May 13, 2016

SUBJECT: PIER 4 PHASE 2 RECONFIGURATION
PROJECT NO. 091251
CONTRACT NO. 070136

ADDENDUM NUMBER SIX

1 DETAIL -TYPICAL PILE CUT-OFF
S7.1 3/4"=1'-0"

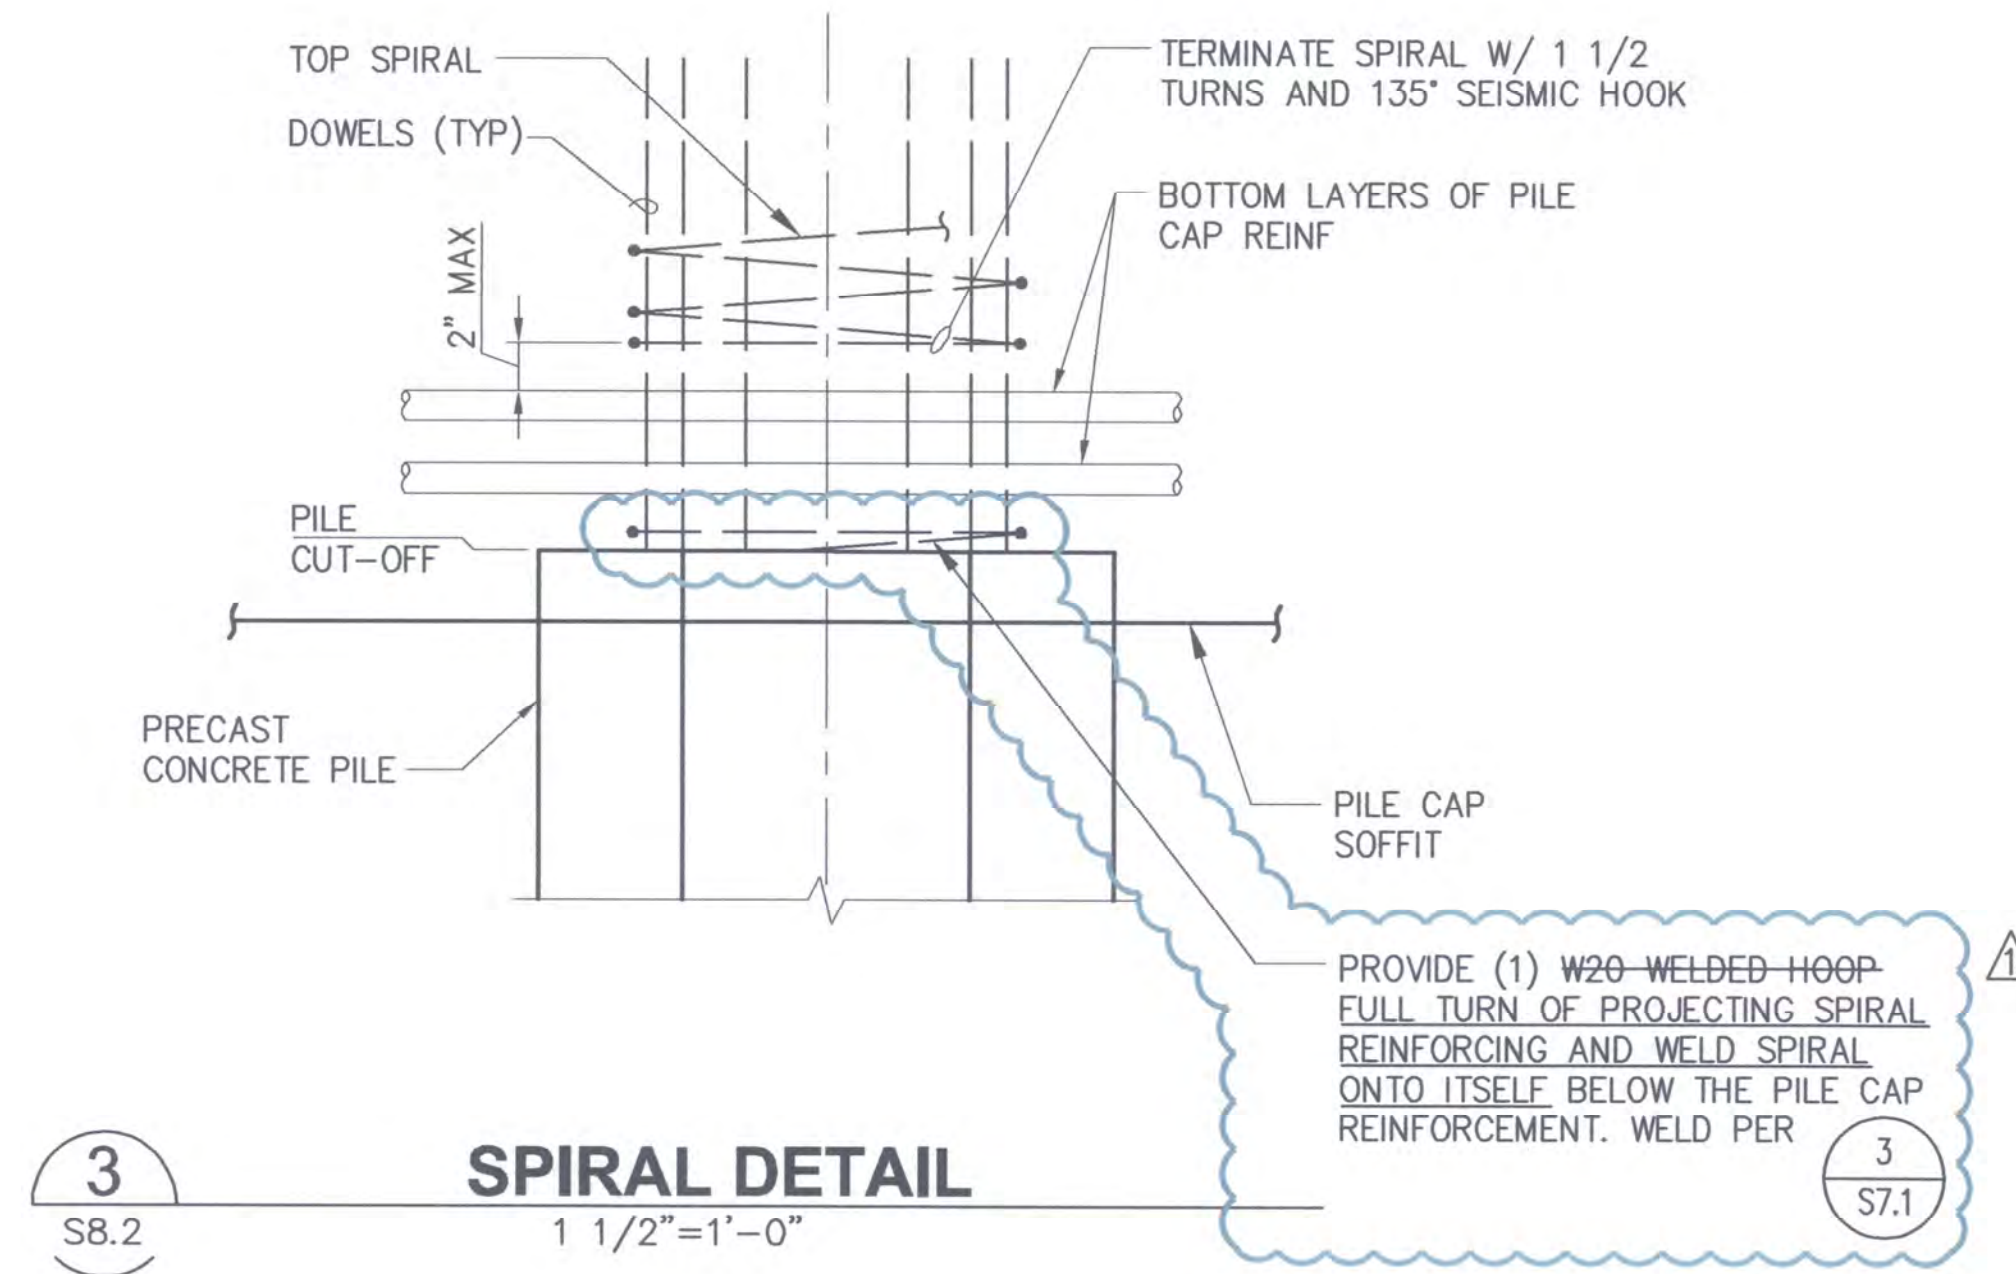
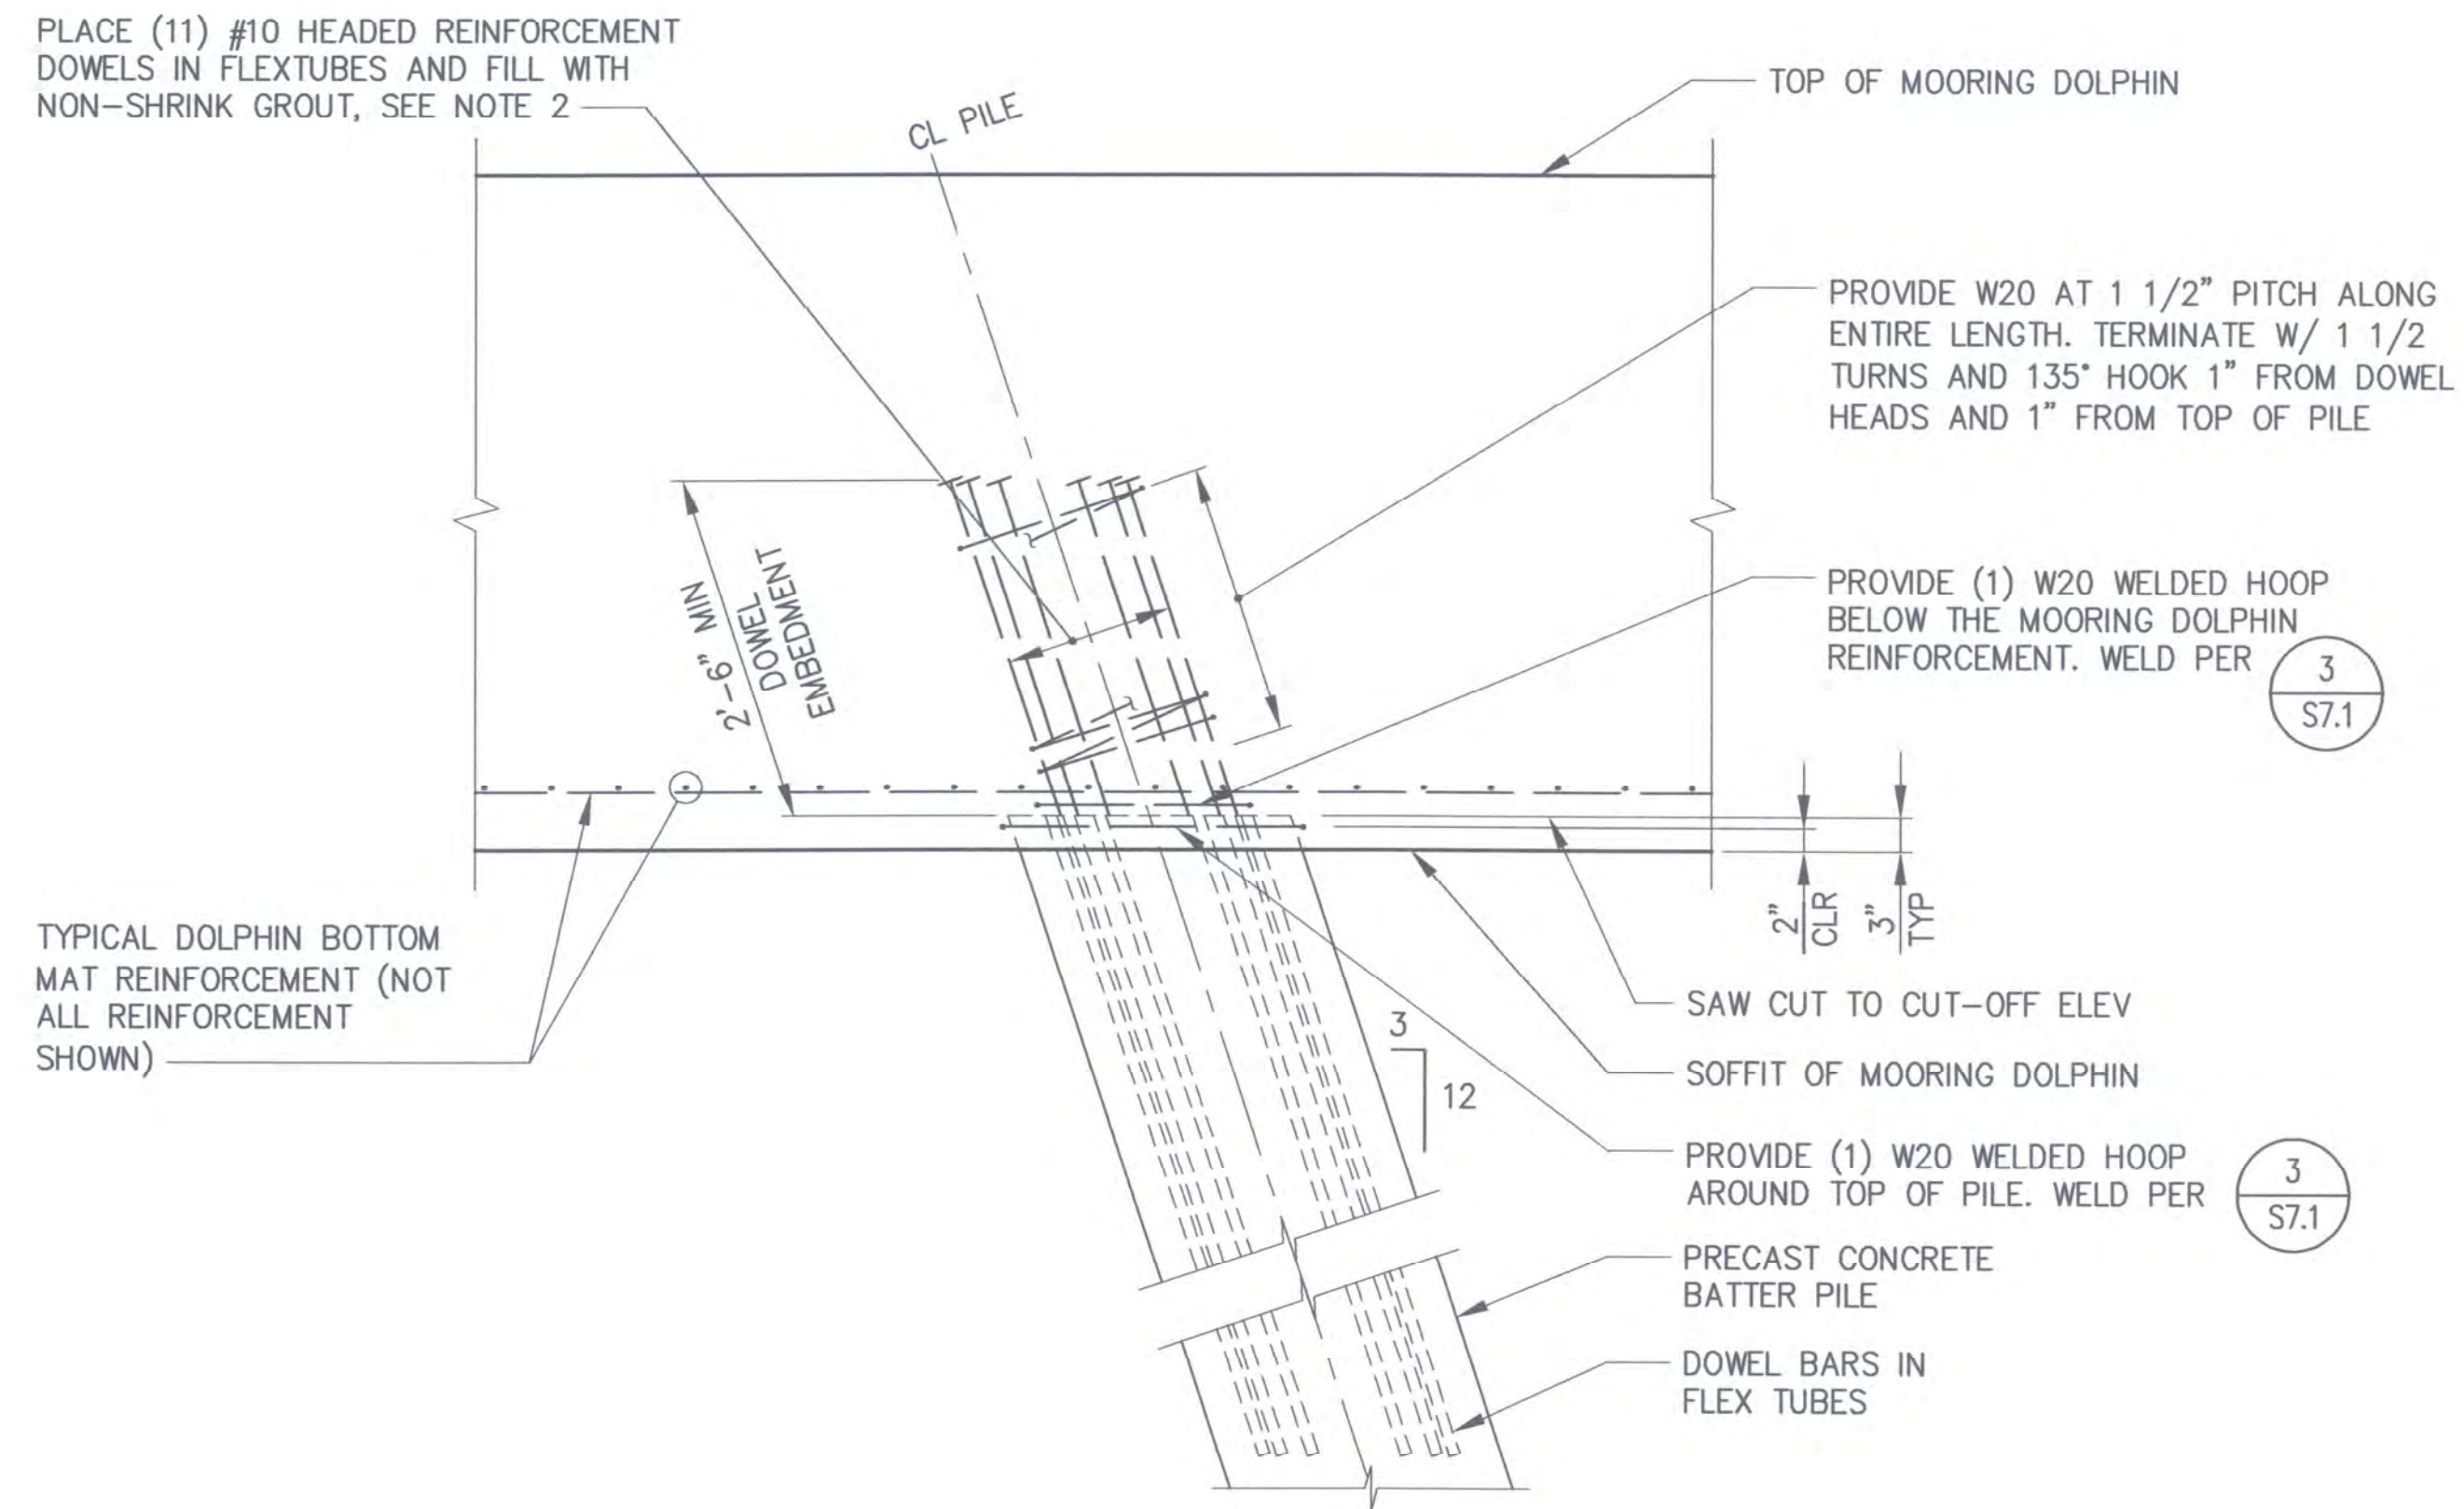
1. **REVISE** Detail 3 Spiral Details as denoted. (See Attachment H to this Addendum No. 6)
